# OPEN SPACE DEVELOPMENT "BROOKVIEW" TAX MAP 186, LOT 13 SPEARE ROAD, HUDSON, NH

Plan Name: **COVER SHEET**  
 Project: **BROOKVIEW SUBDIVISION  
SPEARE ROAD, HUDSON, NH 03051**  
 Owner of Record: **DOUGLAS S. SANDERSON  
11 NERSESIAN WAY, HAMPTON, NH 03842**

**PLANS UNDER REVIEW ENTITLED:** Open Space Development "Brookview" Tax Map 186, Lot 13, Speare Road, Hudson, New Hampshire, prepared by Jones & Beach Engineers, Inc. 85 Portsmouth Ave., PO Box 219, Stratham, NH, dated 10 JUL 15 and revised thru 1 jul 16, consisting of Sheets 1 – 21 (CS, Y1 -Y2, OV1, A1 – A3, C1 – C4, P1, H1, X1 – X2, D1 – D3 & E1) and Notes 1 – 24 on Sheet OV1(said plans are attached hereto).

DRAWING No. **C4**  
SHEET 11 OF 20  
JBE PROJECT NO. 15031

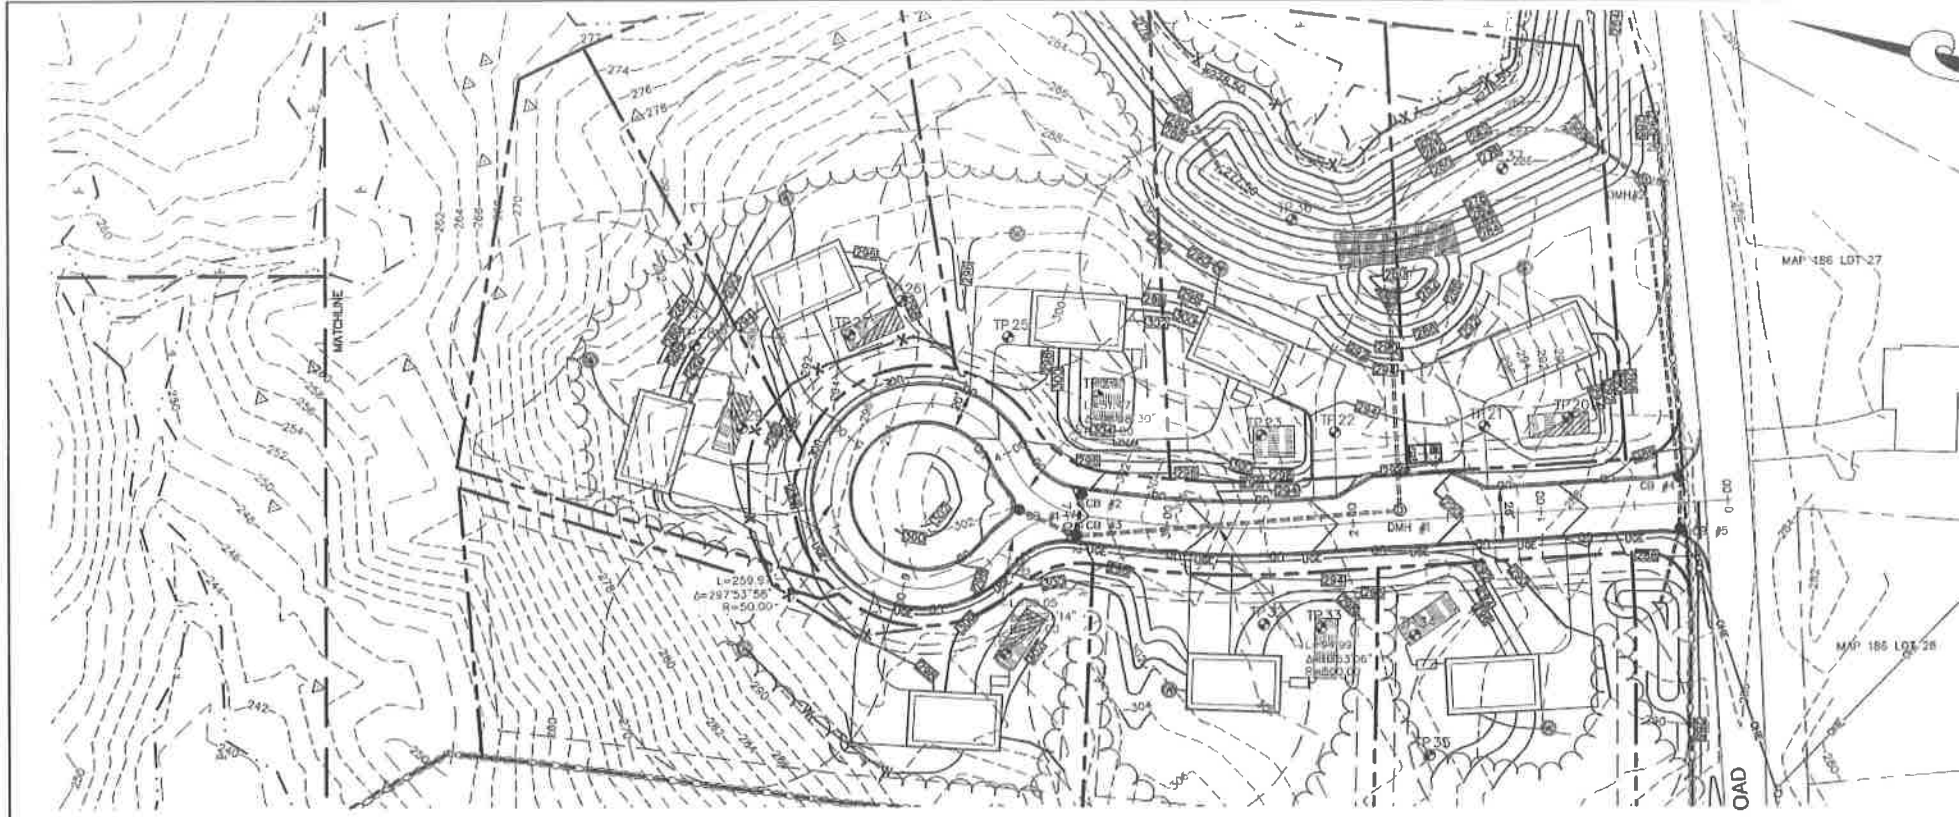
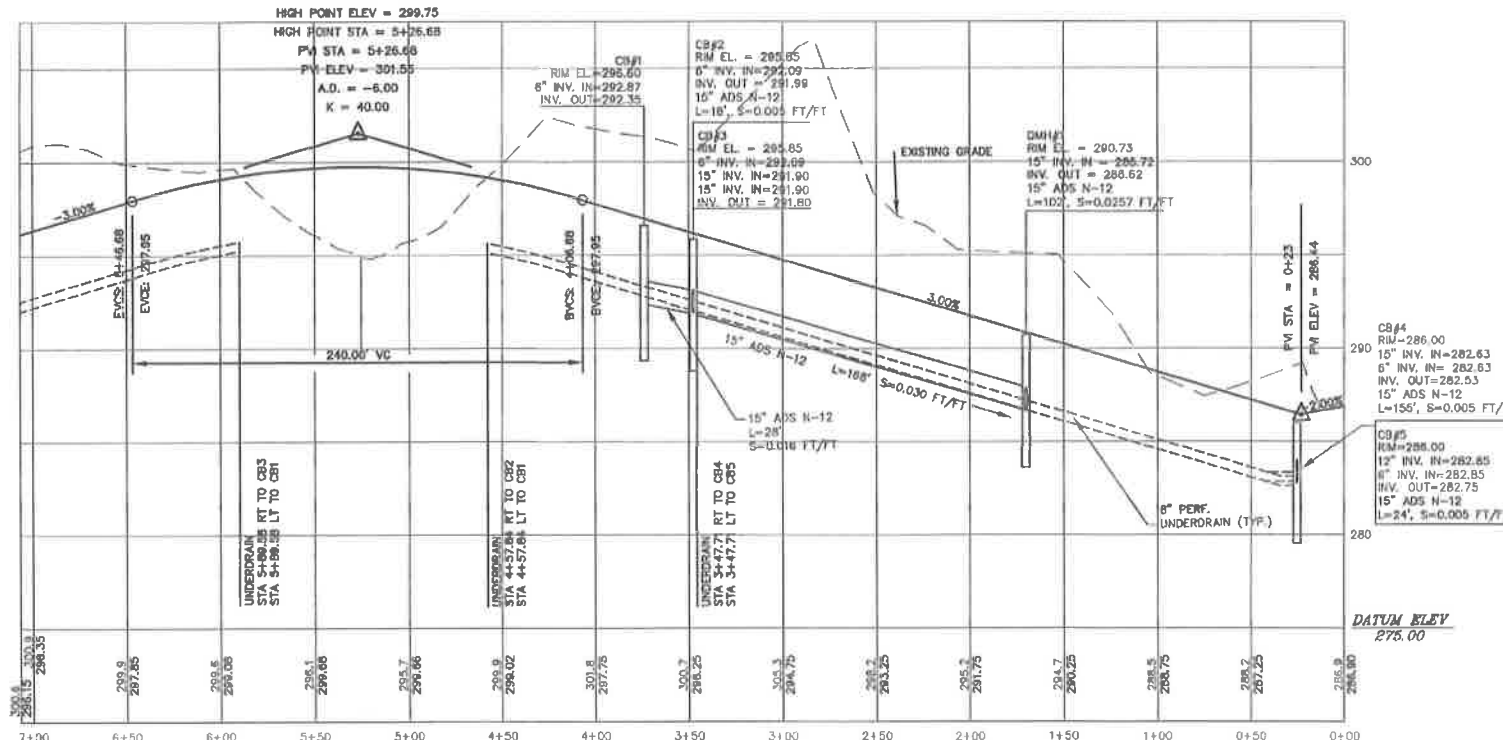
- b. *Former CLD Comment: HR 290-4.A.(3). The applicant should provide Rip Rap dimensions on Sheet C4 for the outlet at DMH#2.*  
Current CLD Comment: The applicant has illustrated the dimensions of Rip Rap on C4 for DMH#2. No further CLD comment.

a. Existing Note 3, Sheet C4, amended to read:  
"3. All benchmarks and topography ~~should~~ **shall** be field verified by the contractor."  
**RESPONSE: This note has been revised on the plans.**

b. Existing Note 38, Sheet C4, amended to read:  
"38. As-built plans shall be submitted to ~~Department of Public Works~~ **the Highway Department and the Planning Board.**"  
**RESPONSE: This note has been revised on the plans.**

**RESPONSE: The driveway grading has been revised so that it does not exceed 10%. Additional grading has been added to the plans to clarify the slab and sill elevations. Some houses are graded with drive under garages. Slab and sill elevations are now noted on Sheet C4.**

DRAWING No. **P1**  
 SHEET 12 OF 20  
 JBE PROJECT NO. 15031

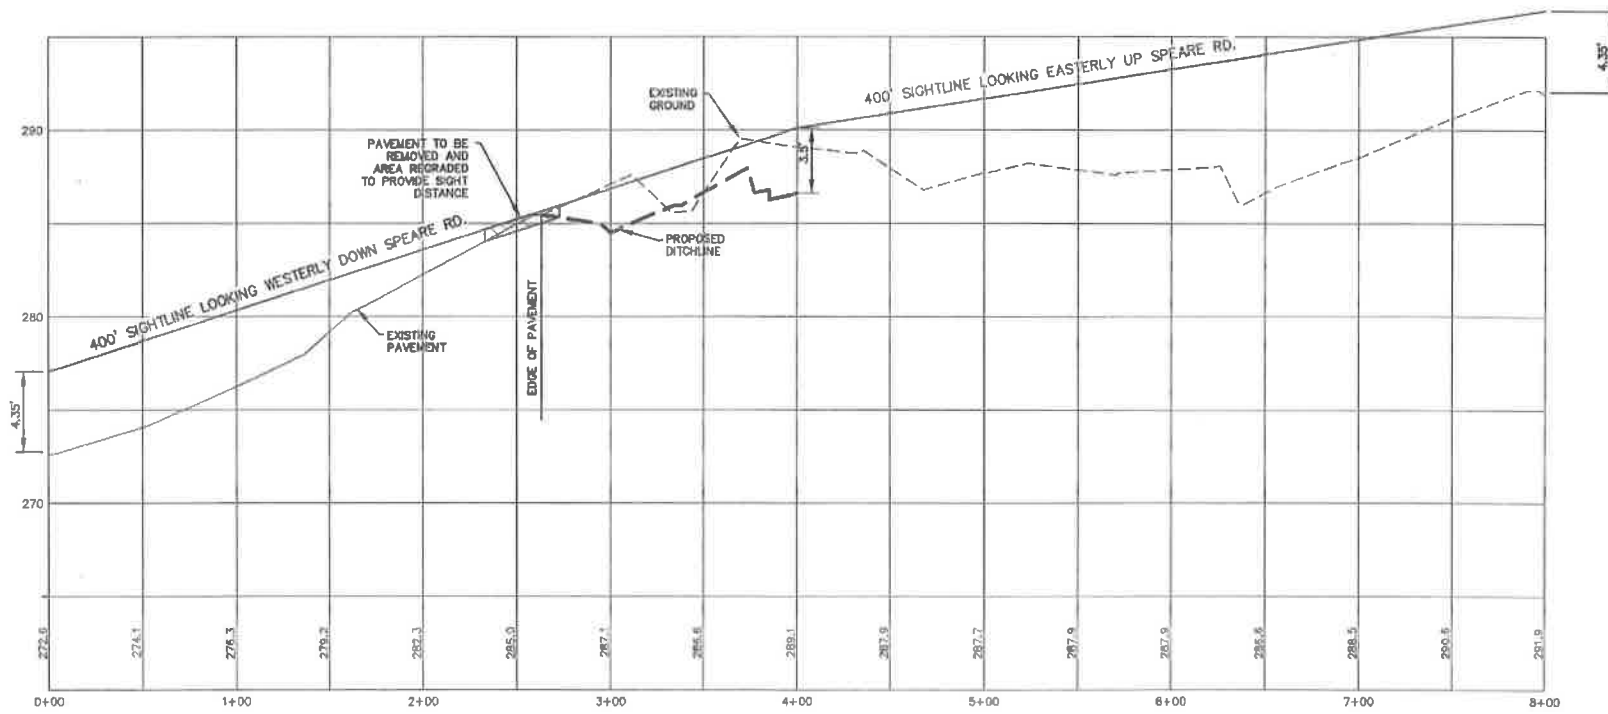
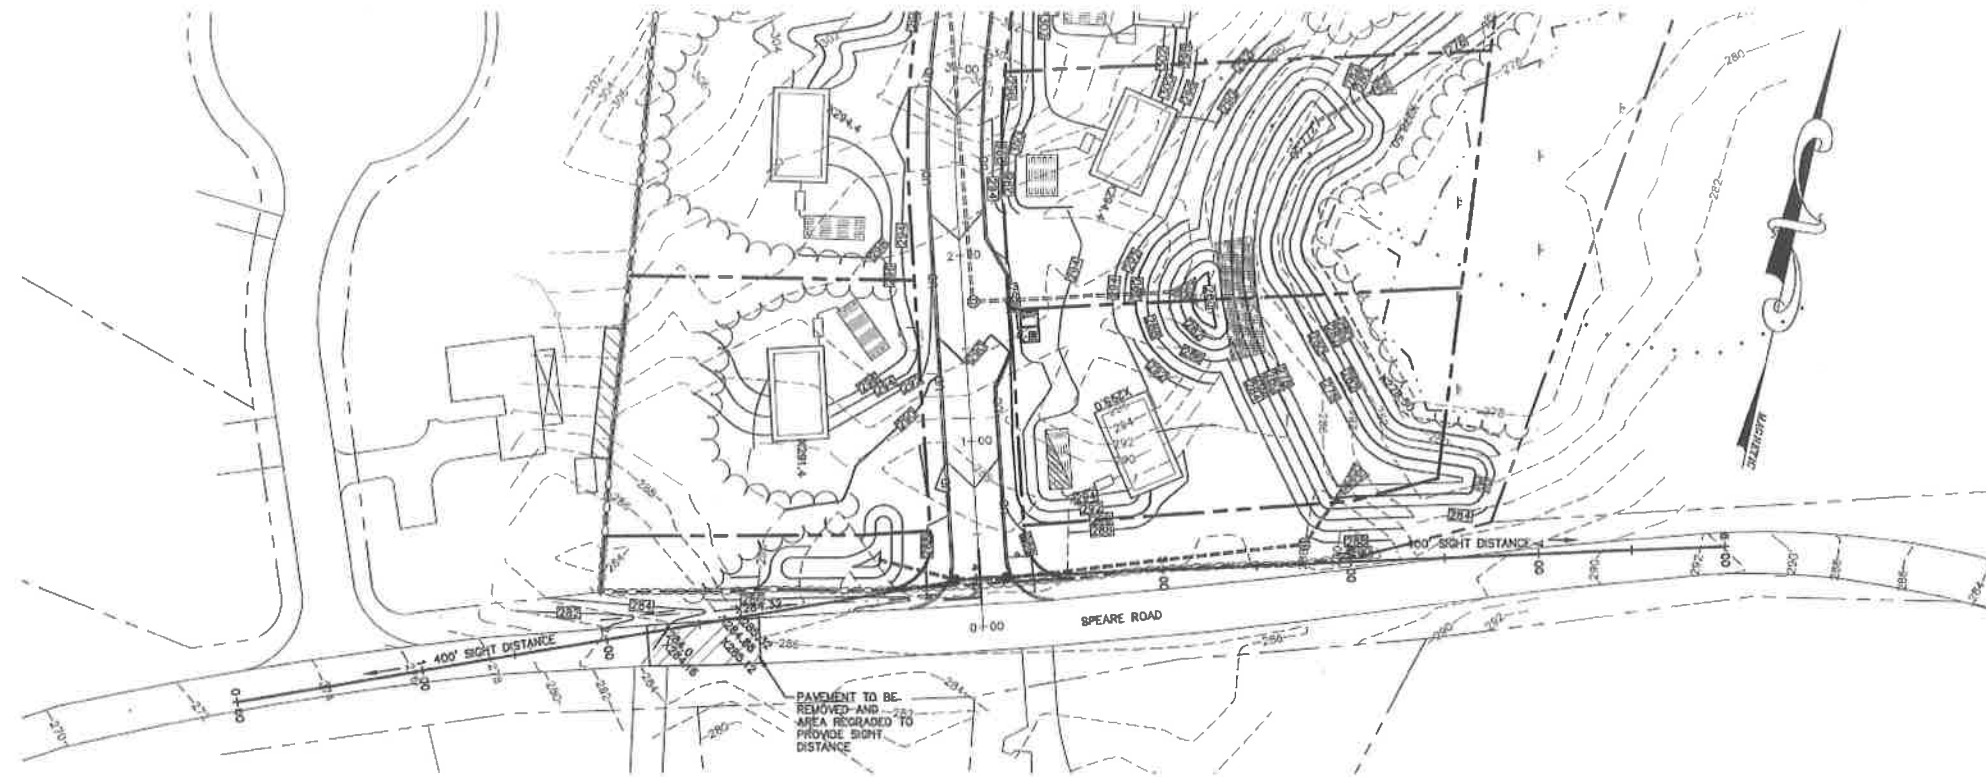
c. Existing Note 15, Sheet P1, shall be deleted, i.e., if the board votes to not require the construction of a sidewalk in this subd. Please note, the Profile Sheets of the Plan set already reflect no sidewalk construction.  
**RESPONSE: Note 15 has been removed from Sheet P1.**

d. Also on Sheet P1, the reference to "detention ponds" should be changed to "detention pond" (singular), i.e., since there is only 1 "detention pond" proposed for this subd.  
**RESPONSE: This note has been revised.**

DRAWING No.	<b>H1</b>
SHEET 13 OF 20 JBE PROJECT NO. 15031

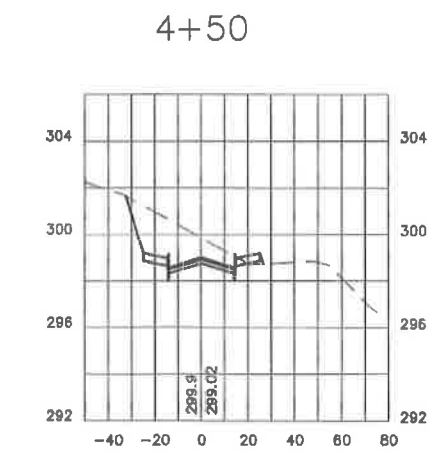
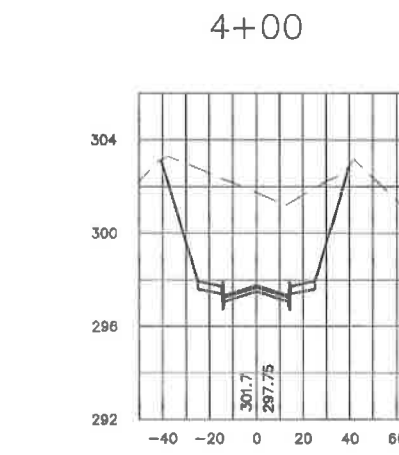
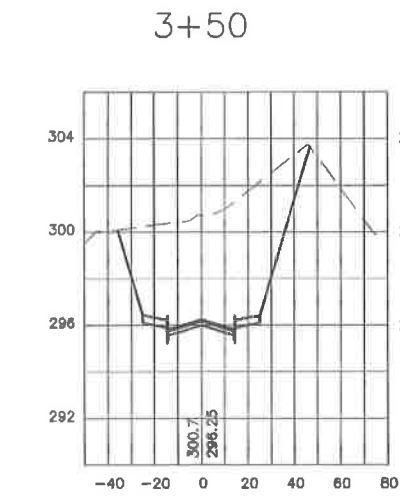
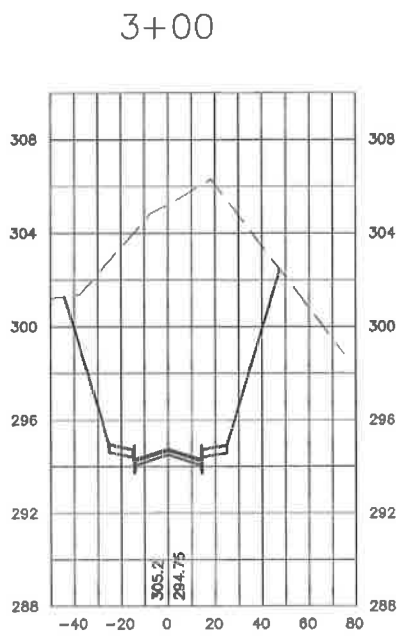
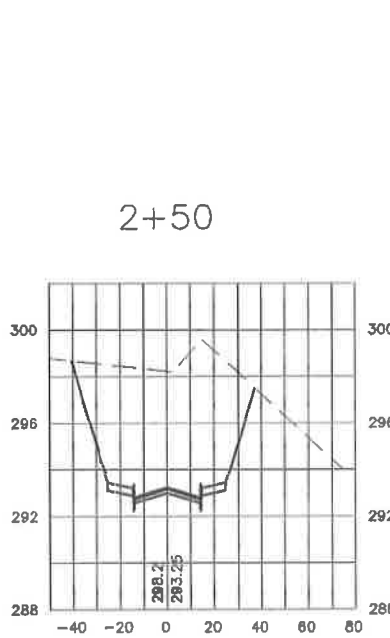
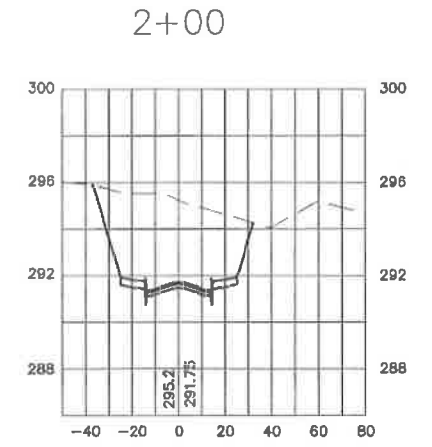
7. The required Safe Stopping Distance, in accordance with §193-10.E. of the Planning Board's Driveway Regulations, has been delineated in the attached Plan set. Please see Sheet H1, which indicates that a section of Speare Rd., approximately 150 ft. west of the proposed intersection, needs to be reduced in height in order to provide the proposed safe stopping distance. Note: the issue of altering Speare Rd. falls within the jurisdiction of the Highway Dept., and an agreement has been reached between the Applicant, the Road Agent, Kevin Burns, and the Town Eng., Elvis Dhima, regarding the subject modification to Speare Rd.

**'DEAD END' SIGN (W14-1)**

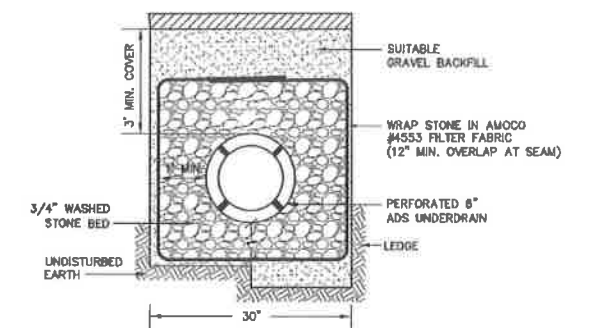
- d. Former CLD Comment: HR 289-18.B.5. The applicant has not provided a "not a through street" informational sign in accordance with the Regulation.  
*Current CLD Comment: The applicant has noted a "Dead End" street sign, but should provide a detail for Town review.*  
**RESPONSE: A "Dead End" Sign Detail has been added to Sheet D2.**
